VIRGINIA ELECTRIC AND POWER COMPANY
RICHMOND, VIRGINIA 23261

September 19, 2019

Serial No.: 19-374
NRA/GDM: R1
Docket Nos.: 50-280/281
License Nos.: DPR-32/37

VIRGINIA ELECTRIC AND POWER COMPANY
SURRY POWER STATION UNITS 1 AND 2
PROPOSED LICENSE AMENDMENT REQUEST
UPDATE OF REACTOR COOLANT SYSTEM HEATUP AND COOLDOWN
PRESSURE-TEMPERATURE LIMITATIONS FIGURES FOR SUBSEQUENT
LICENSE RENEWAL

Figure 3.1-1 : Surry Units 1 and 2 Reactor Coolant System Heatup Limitations (Heatup Rates up to 60°F/hr) Applicable for ~~48~~ EFPY

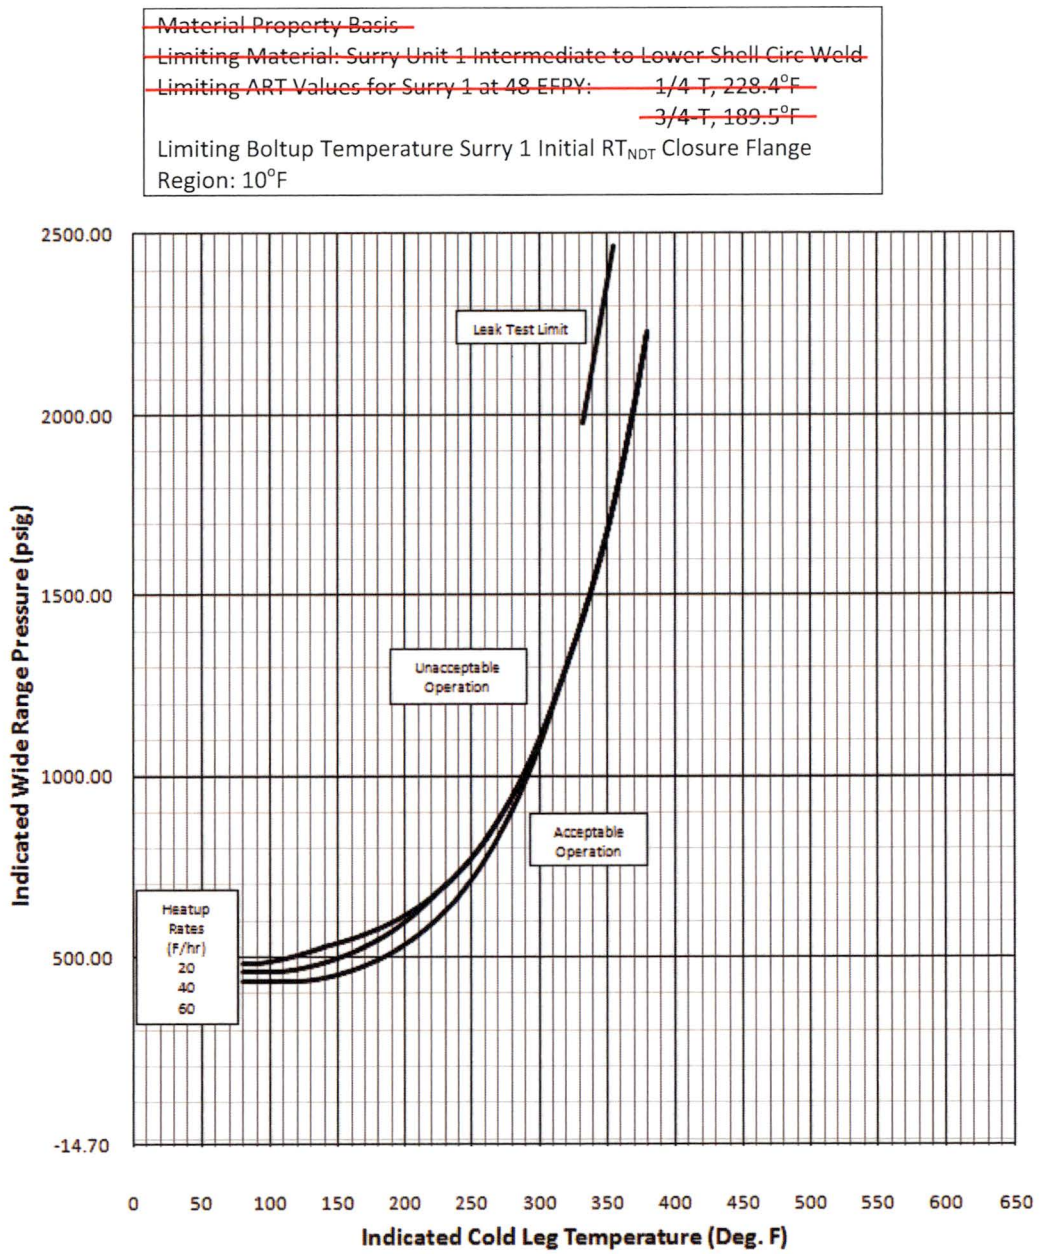
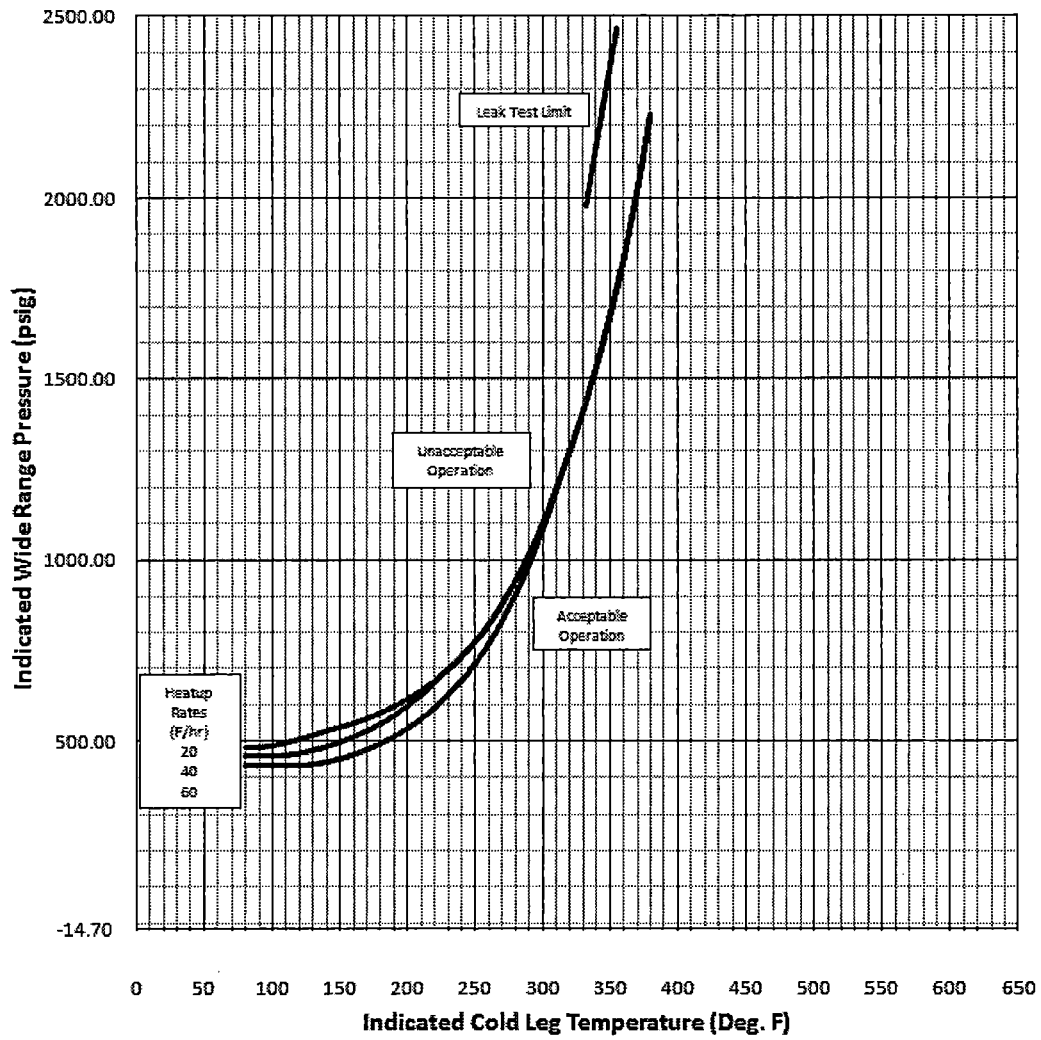
- The proposed change revises the existing TS Figure 3.1-1 and 3.1-2 titles, respectively, from:

Surry Units 1 and 2 Reactor Coolant System Heatup Limitations (Heatup Rates up to 60°F/hr) Applicable to 48 EFPY

*Surry Units 1 and 2 Reactor Coolant System Heatup Limitations (Heatup Rates up to 60°F/hr) Applicable to **68 EFPY [BOLD emphasis added]***

- The proposed change revises and relocates to the TS 3.1 Basis the existing Material Property Basis information contained in the informational block located above each curve. (See Item 3 below.) The revised information includes the Limiting Material and Limiting Adjusted Reference Temperature (ART) values associated with plant operation up to the SLR cumulative core burnup applicability limit of 68 EFPY, as opposed to the existing limit of 48 EFPY associated with the first license renewal for Surry Units 1 and 2.

68

Figure 3.1-1 : Surry Units 1 and 2 Reactor Coolant System Heatup Limitations (Heatup Rates up to 60°F/hr) Applicable for 68 EFPY

Figure 3.1-2 : Surry Units 1 and 2 Reactor Coolant System Cooldown Limitations (Cooldown Rates up to 100°F/hr) Applicable for ~~48~~ EFPY

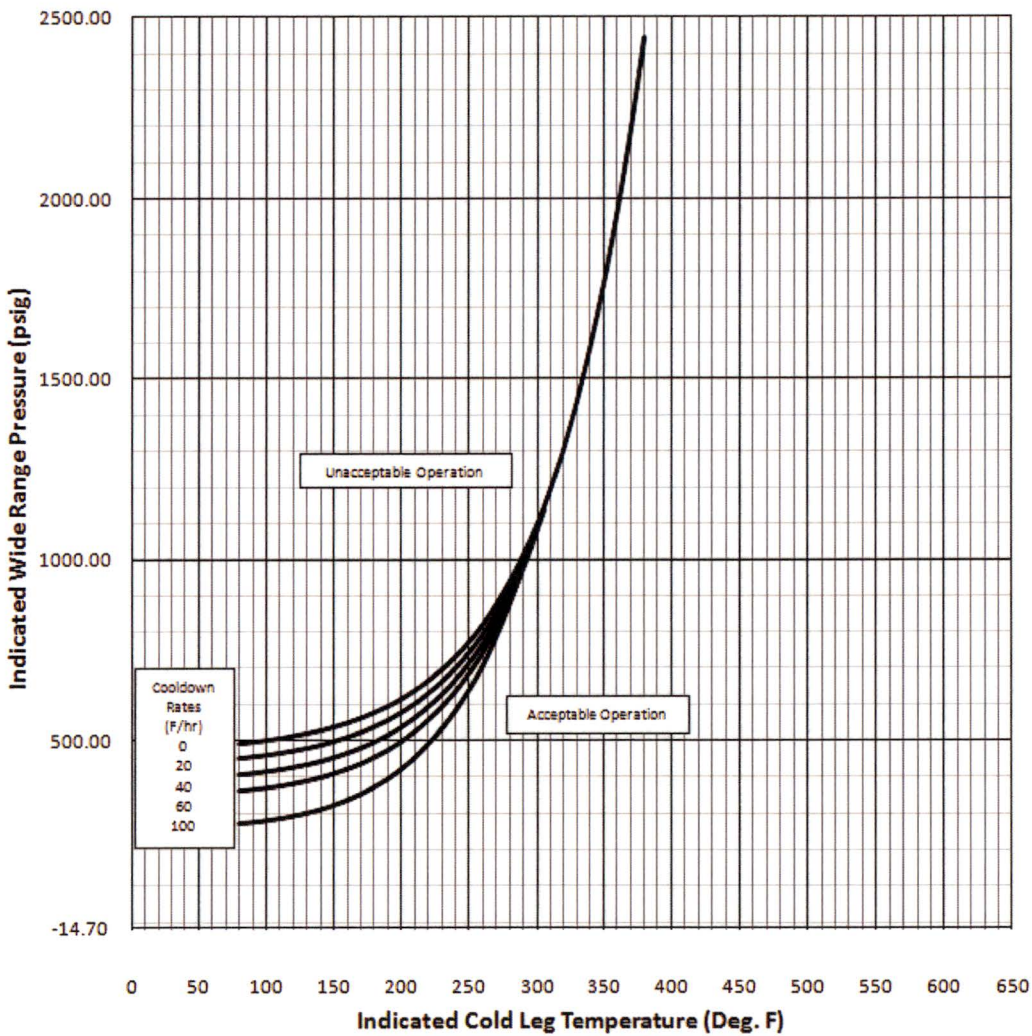
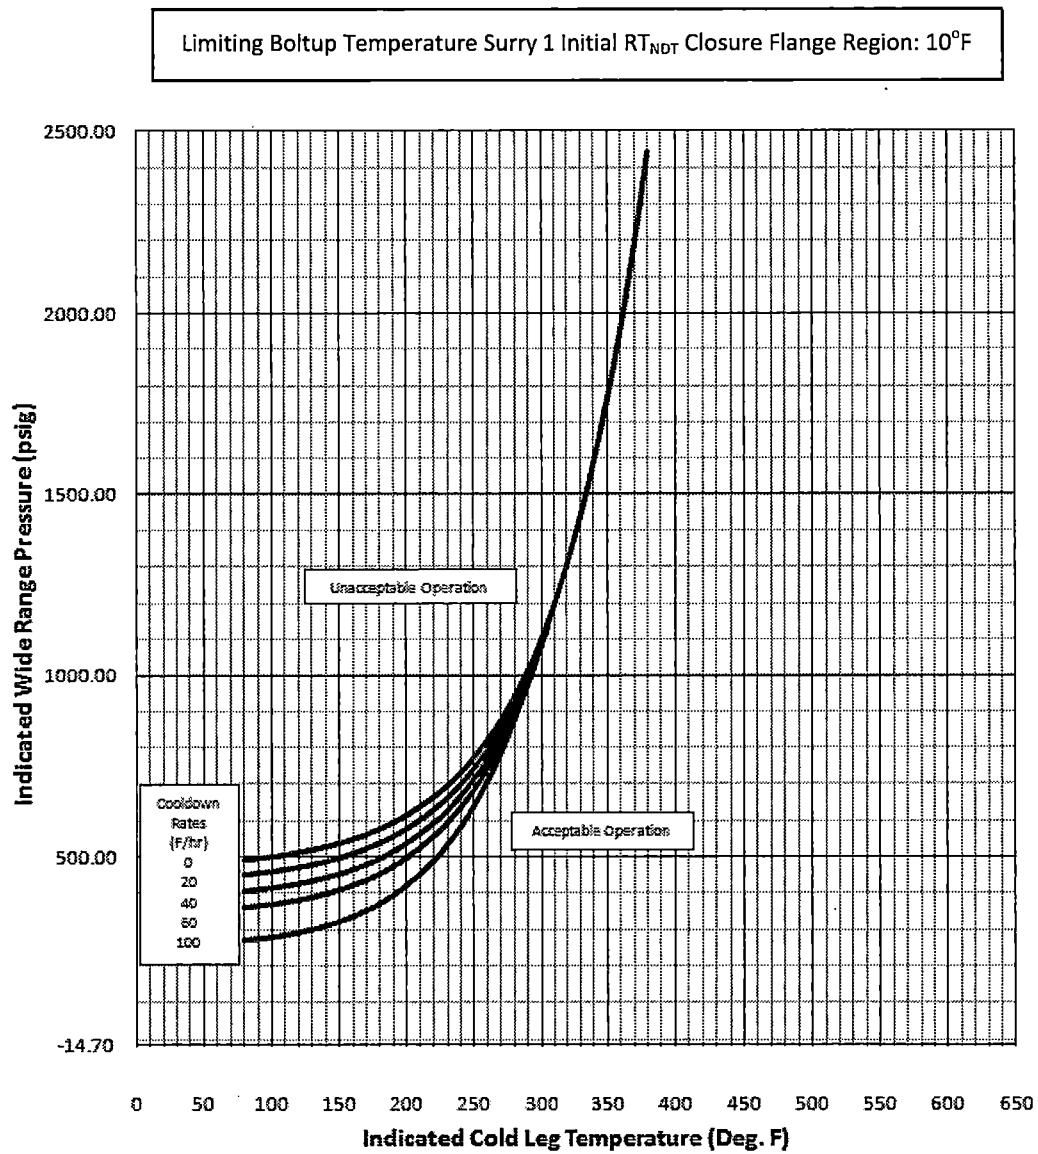
Surry Units 1 and 2 Reactor Coolant System Cooldown Limitations (Cooldown Rates up to 100°F/hr) Applicable to 48 EFPY

*Surry Units 1 and 2 Reactor Coolant System Cooldown Limitations (Cooldown Rates up to 100°F/hr) Applicable to **68 EFPY [BOLD emphasis added]***

68

Figure 3.1-2 : Surry Units 1 and 2 Reactor Coolant System Cooldown Limitations (Cooldown Rates up to 100°F/hr) Applicable for 68 EFPY
